OAK RIDGE NATIONAL LABORATORY

TO: Radioactive Operations Review Committee

RE: Minutes of Meeting Held on October 5, 1959

Subject for Discussion: Gaseous Waste Disposal at ORNL (I)

Concentration of Sr and Ru 106 in Waste Discharged to Pits.

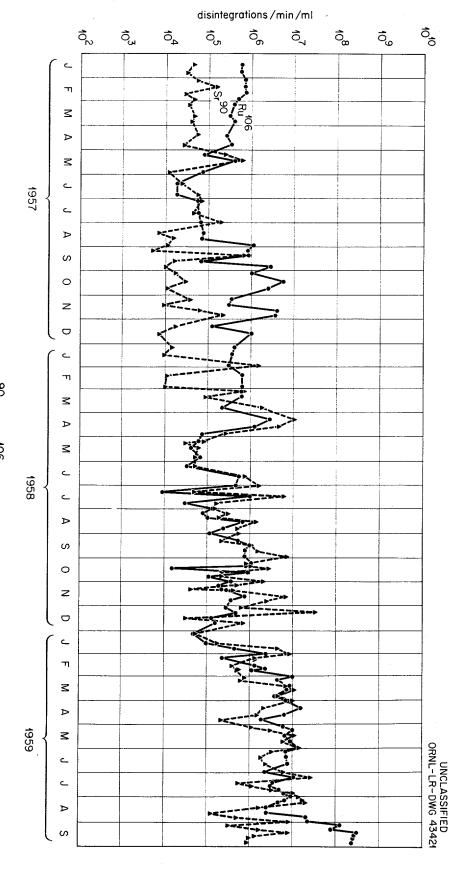
Cowser reviewed the situation at the pits by presenting a graph summarizing the various radioactive species released to Pit 3 from 1957 until September 1959 (see Appendix), including the activity levels of the most important fission products, ruthenium-106 and strontium-90. For both of these isotopes, the activity level increased from several units of 105 counts/milliliter/minute in 1957 to a value between $10^6 - 10^7$ c/ml/min in the fall of 1959. Some of the Sr⁹⁰ was retained at the tank farm; however, this is dependent on the operating practice followed, as the material is not deliberately settled out During the month of September the amount of ruthenium going to the pits increased from about 47,000 curies to about 162,000 curies, part of which was Ru¹⁰³. Decay was not taken in consideration in computing these figures. The graph indicated that through 1958, 22,000 cumulative curies of ruthenium were released, reaching 162,000 curies by the end of September 1959, including Ru¹⁰³. Although the ruthenium went up by a factor of 10 and will do so again if the present rate is maintained, this element is not the most important from the point of view of radiation hazard, the strontium-90 is more dangerous. 1957, from sources other than the process waste system, 58 curies of ruthenium were discharged to the river and only 2 curies originated in the process waste system. During that time curies of ruthenium left the pit area and are held in the bed of White Oak Lake.*

Although this level is acceptable, Bruce and Jordan expressed concern about a potential ten to hundredfold increase in the future. Morgan commented that currently strontium is the chief problem but agreed that a sizeable increase in the ruthenium level will bring this element also to a dangerous level. Perhaps steps should be taken to remove this element prior to sending the waste to the pits. Assuming that the level and flow rate will be at the same high level as during these past months, Cowser stated that the total of 5 million gallons per year will result in 1 million curies, or a factor of more than 100 compared to 1957. Jacobs pointed out that this is a limiting case, being based on the assumption that all the ruthenium comes from the waste pits.
